SIMTA Intermodal Terminal Facility- Stage 1

Response to Submissions -Air Quality Addendum

SIMTA STAGE 1 - REVIEW OF AIR QUALITY EFFECTS FOR AMENDED RAIL LINK ALIGNMENT

Figure 1: Alternative Rail link and overview of the Proposal

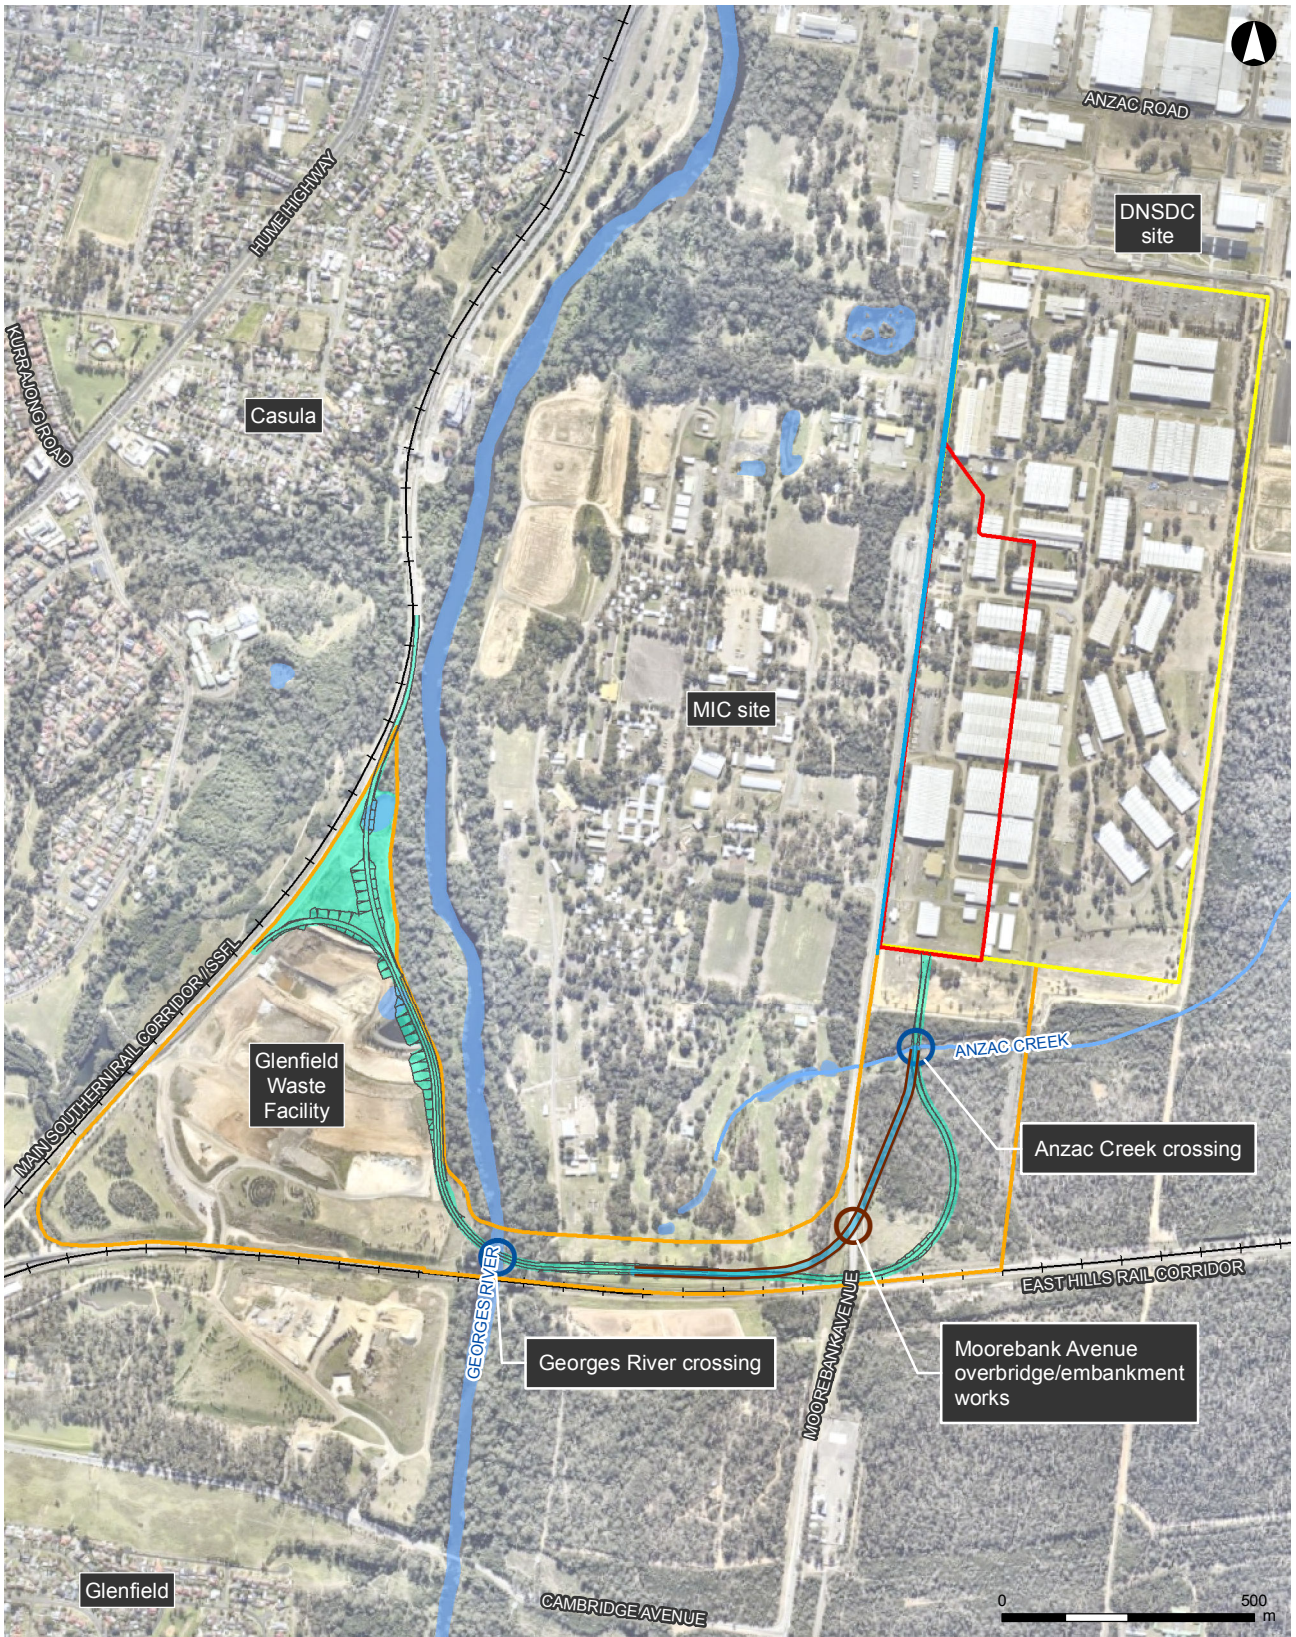
The Rail link is to be realigned within Commonwealth Land (including MIC Site, Moorebank Avenue and the Southern Boot Land) to respond to submissions (received during the exhibition of the EIS (28 May 2015 and 26 June 2015)) and also to reduce the overall environmental impacts of the Proposal (refer to **Figure 1**).

This realignment would alter the Rail link alignment to the south of the Anzac Creek Crossing, at the intersection with Moorebank Avenue and also on the MIC site (to the immediate west of Moorebank Avenue). The rail alignment would retain the 20 metre width of the Rail Link Corridor within environmentally sensitive areas, as per the Concept Plan Approval (MP 10_0193) and the EIS.

This alteration in the rail alignment would result in Moorebank Avenue being intersected by Rail link further north of that previously identified within the EIS.

An alteration would be undertaken to the existing Moorebank Avenue road embankment to create an overbridge to accommodate the realigned Rail link.

As shown in **Figure 1**, the amended Rail link provides a more direct route to the alignment proposed within the EIS. For the section of the Rail link that is re-aligned, there is a shift west, away from Wattle Grove and towards the MIC site. The re-alignment would move modelled source locations approximately 150m as the widest separate point to the EIS alignment. This marginal change would

have little or no impact on the predicted ground level concentrations presented in the AQIA, considering separation distances of approximately 2km to the closest sensitive receivers to the west.
